# Monthly Specification Update

Intel® Server Board S5520UR

*Intel Order Number E69054-001*

**July 2011**

**Figure 1. Removing the Heatsink**

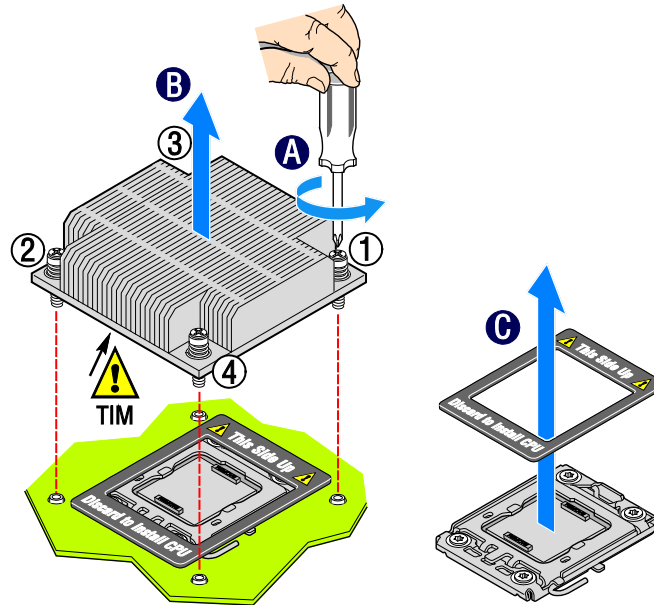
**Problem:** The current documentation does not properly describe the installation and removal of the heatsink. Careful insertion and removal of the heatsink is required to prevent damage to the heatsink screws or backplate.

1. Loosen the four captive screws on the heatsink corners in a diagonal manner according to the numbers shown in figure 1 as follows:
  - Starting with the screw at location 1, loosen it by giving it **two rotations** in the anticlockwise direction and stop. (**IMPORTANT:** Do not fully loosen.)
  - Proceed to the screw at location 2 and loosen it by giving it two rotations and stop.
  - Loosen screws at locations 3 and 4 by giving each screw two rotations and then stop.
  - Repeat steps 1a through 1c by giving each screw two rotations each time until all screws are loosened.
2. Do one of the following:
  - If removing the heatsink for the first time, do the following:
    - i. Lift the heatsink from the board.
    - ii. Remove and discard the spacer (see letter “C” in figure 1).

**Workaround:** Perform the steps outlined below for installation and removal of the heatsink to avoid damage.

Figure 2: Installing the Heatsink

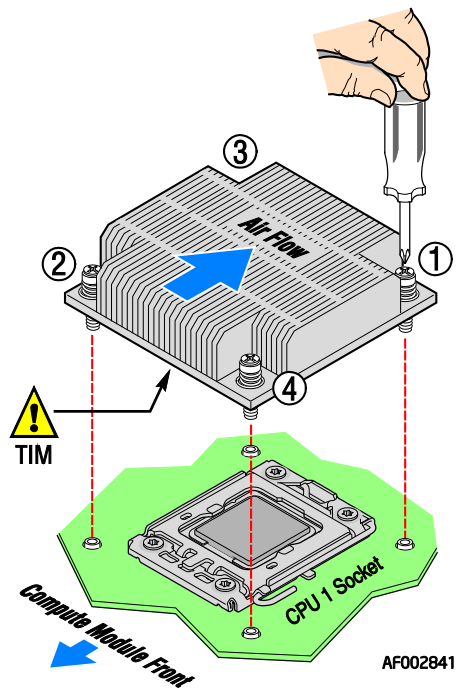
2. Orient the heatsink over the processor as shown in Figure 2. The heatsink fins must be positioned as shown to provide correct airflow through the system.

3. Set the heatsink over the processor, lining up the four captive screws with the four posts surrounding the processor.
4. Loosely screw in the captive screws on the heatsink corners in a diagonal manner according to the numbers shown in Figure 2 as follows:

- a. Starting with the screw at location 1, engage the screw threads by giving it **two rotations** in the clockwise direction and stop. (**IMPORTANT:** Do not fully tighten.)

- d. Repeat steps 4a through 4c by giving each screw two rotations each time until all screws are lightly tightened upto a maximum of 8 inch-lbs torque.
